MEMORANDUM

To: Salt Lake City Planning Commission

From: David J. Gellner, AICP, Principal Planner 385-226-3860, david.gellner@slcgov.com

Re: Modifications to the Book Cliffs Apartments at approximately 1159 S. West Temple St.
Conditional Building and Site Design Review PLNPCM2017-00708

D1 West Exterior Elevation
1/8" = 1'-0"

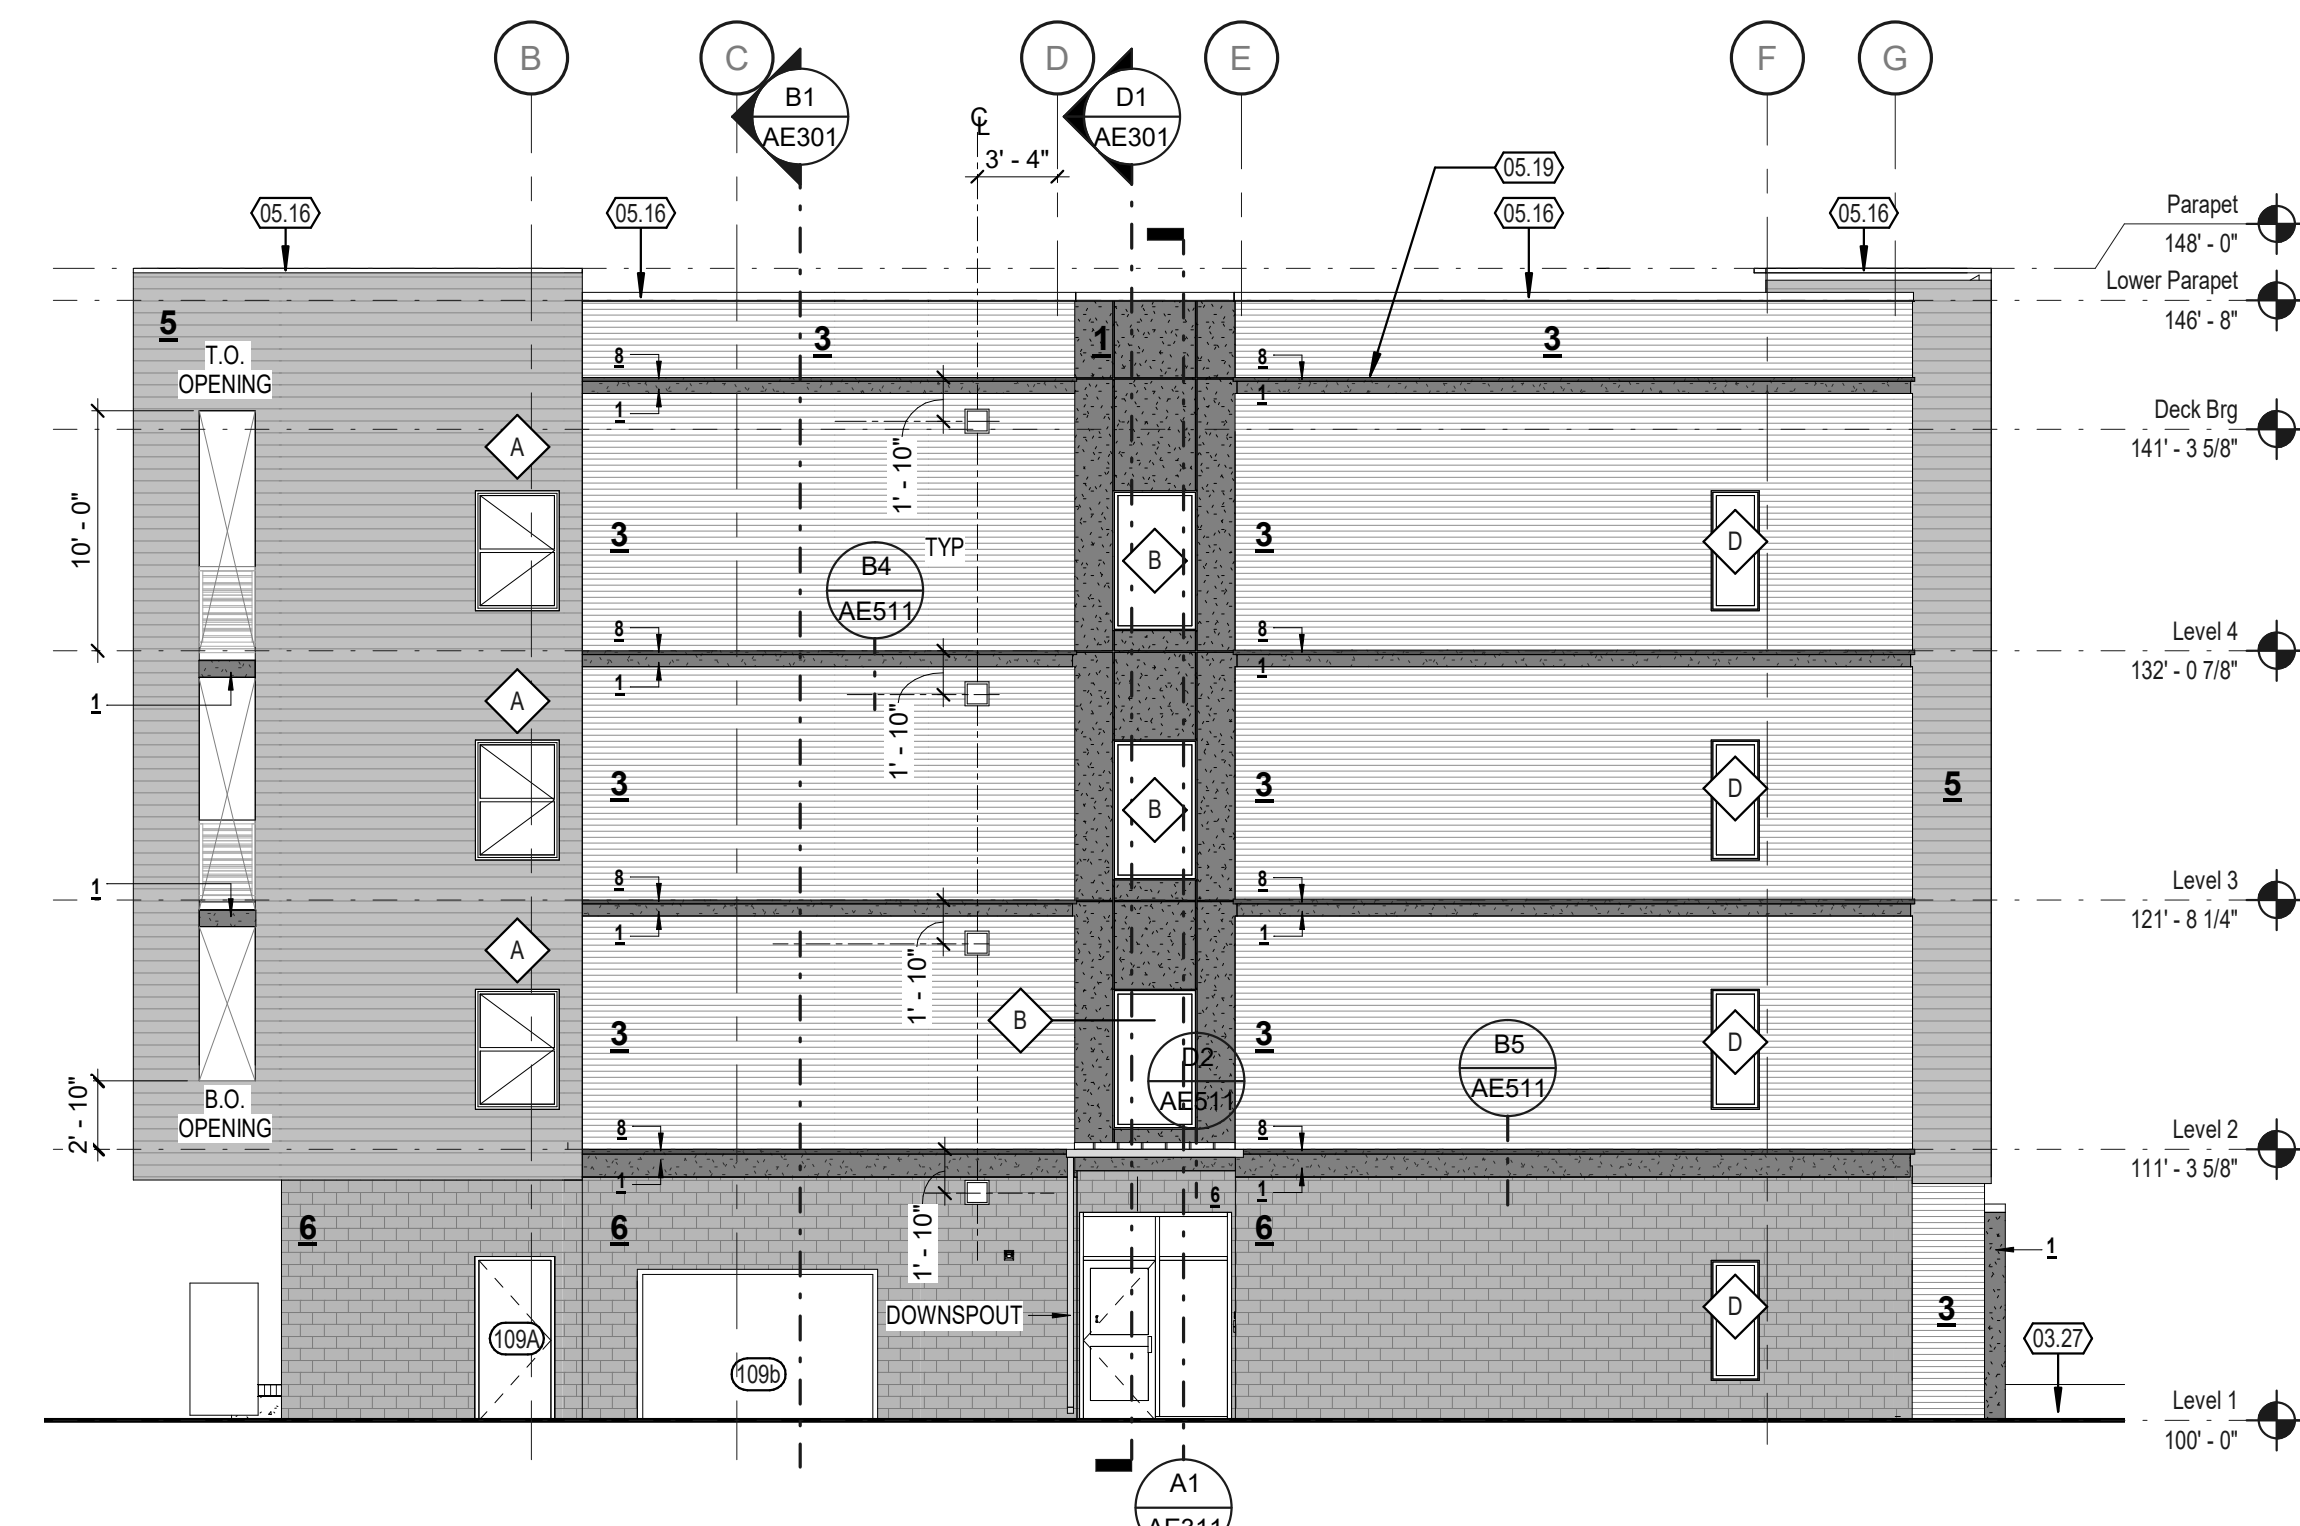
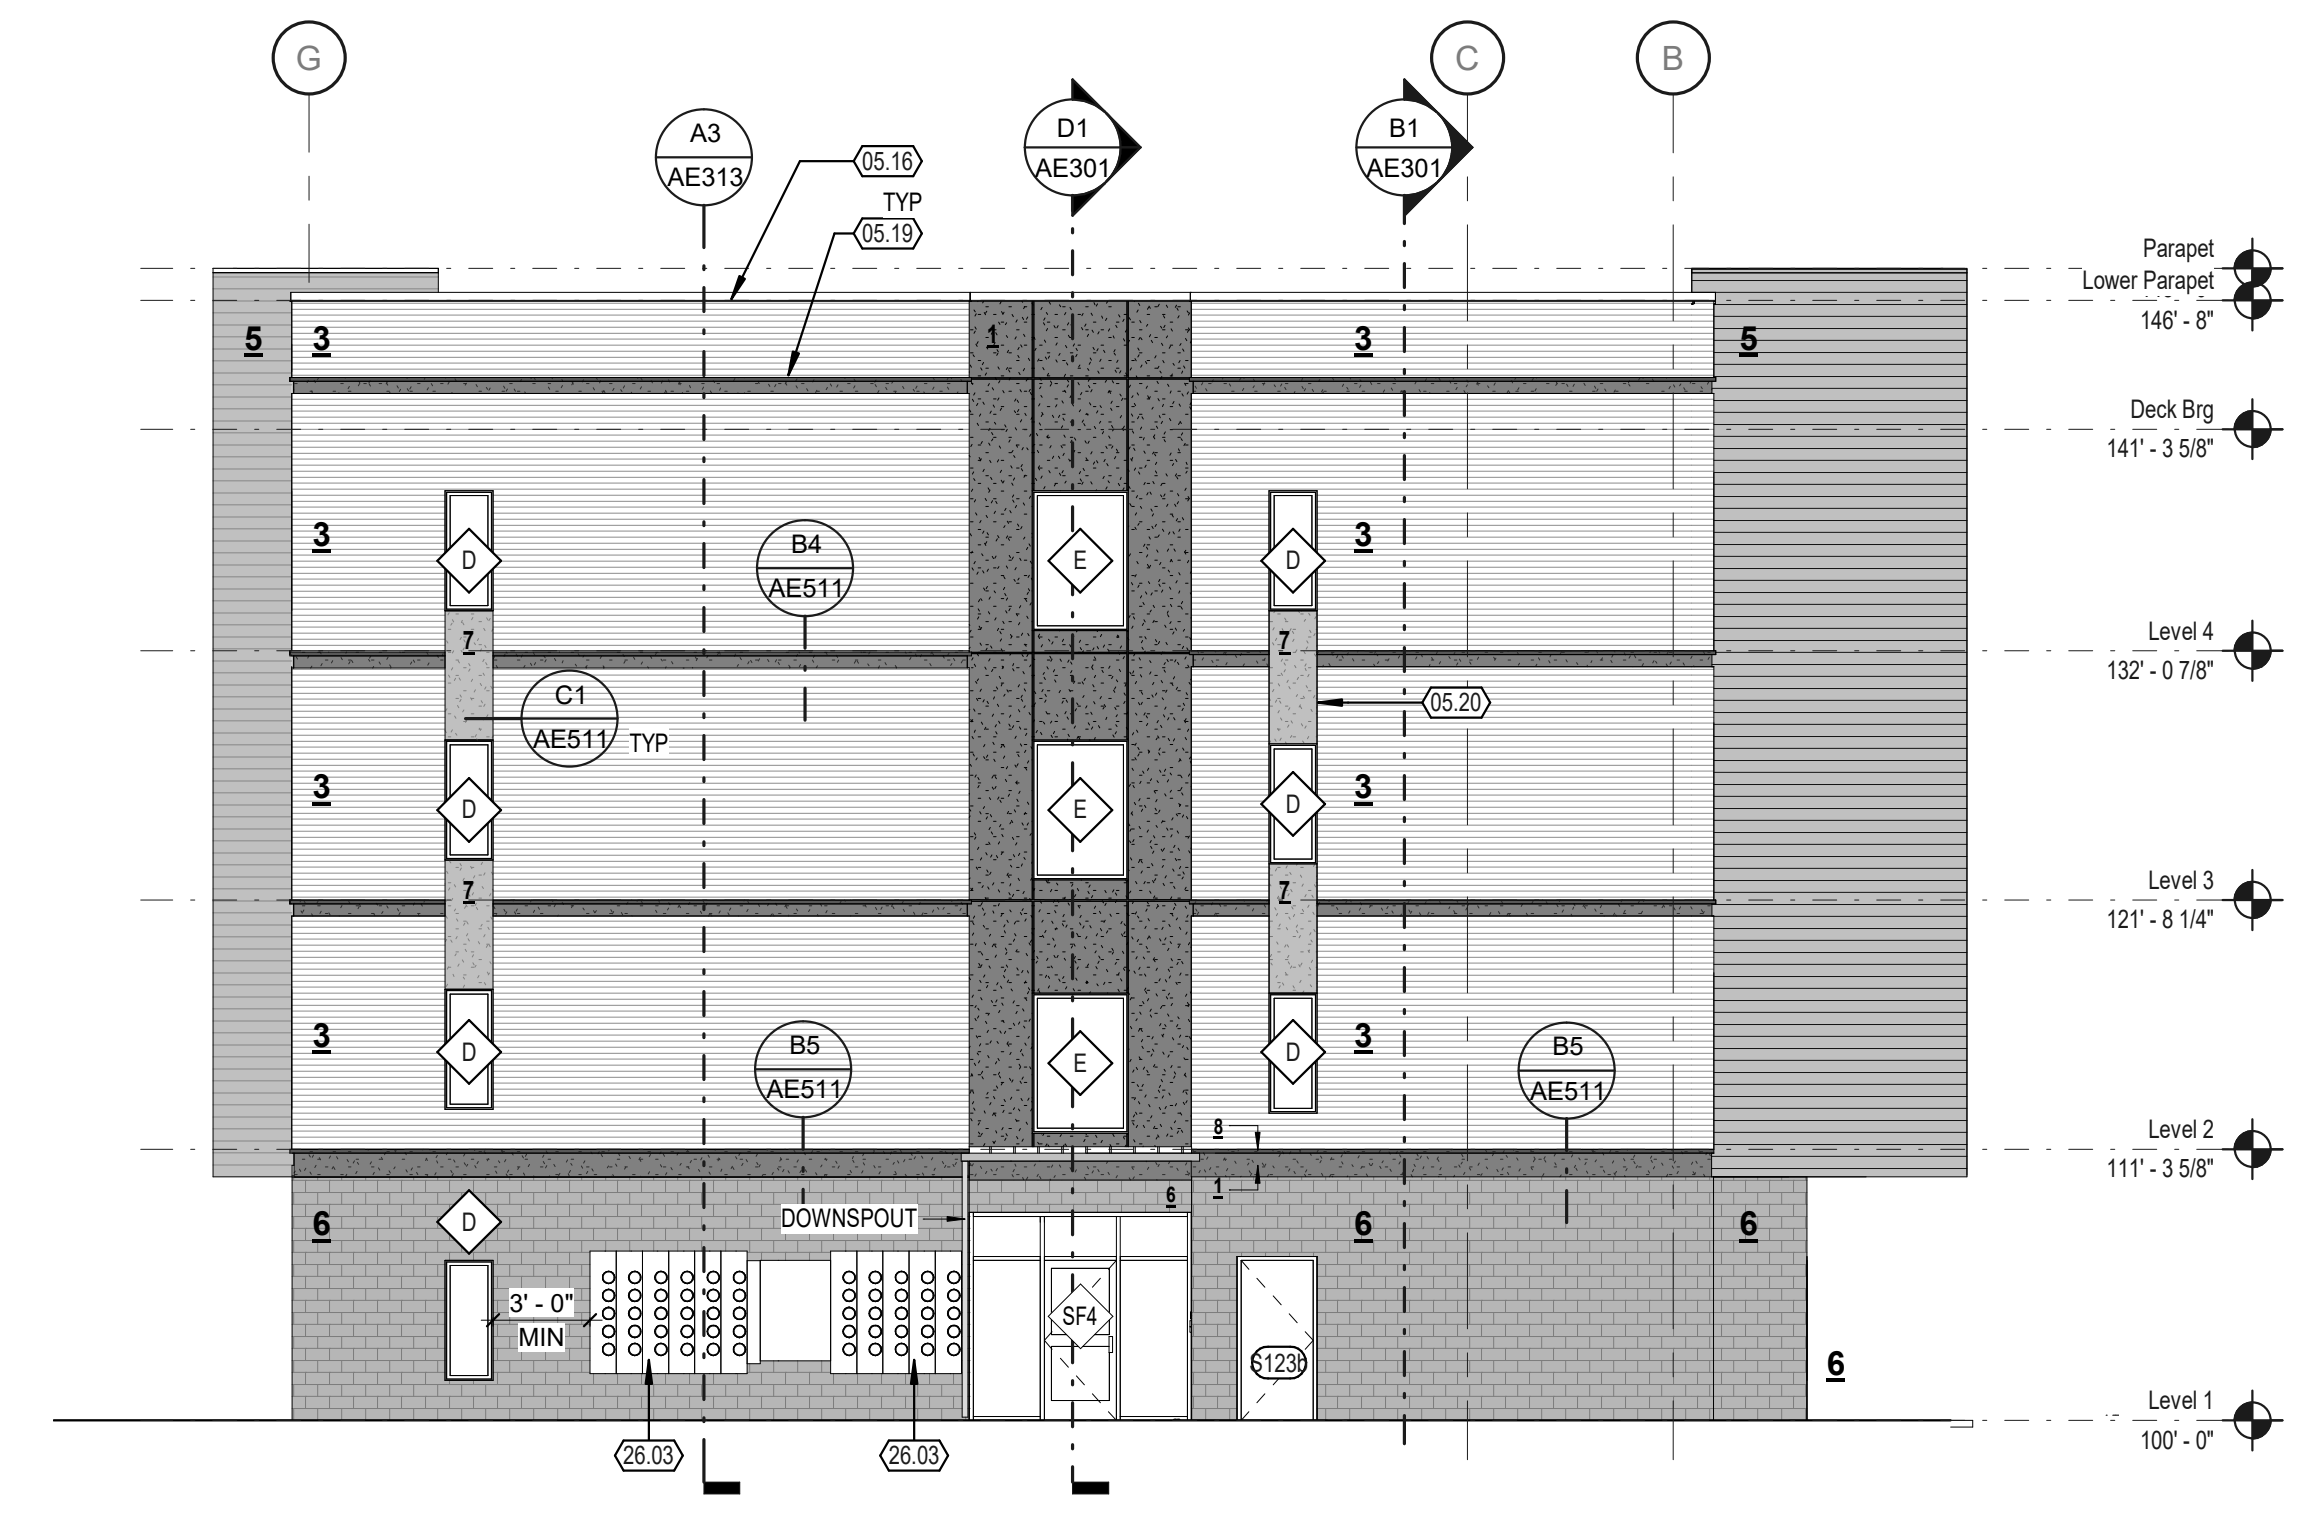
During the original hearing, the Planning Commission signaled concern about the west façade along West Temple St. As was discussed before, the main entrance of the original design was facing east due to the desire to be culturally sensitive in their design. The Commission

To respond to that condition the applicant added a series of entrances into private residential units as well as a main entrance into the lobby of the structure along the West Temple St. frontage. These entrances will pull pedestrian traffic directly onto the sidewalk rather than forcing them through the rear parking lot. Increased pedestrian interest will occur by providing 25 percent of glazing on the ground floor. The CC zoning district does not require any glazing on the ground floor of a structure.

Articulation was added to the structure with added depth to the balconies and symmetrical architectural features which frame the windows from the second to the fourth levels of the structure. Adjustments to the roof line were also added providing additional visible interest to the structure. The remaining facades were modified to be compatible with the modifications made to the street facing façade.
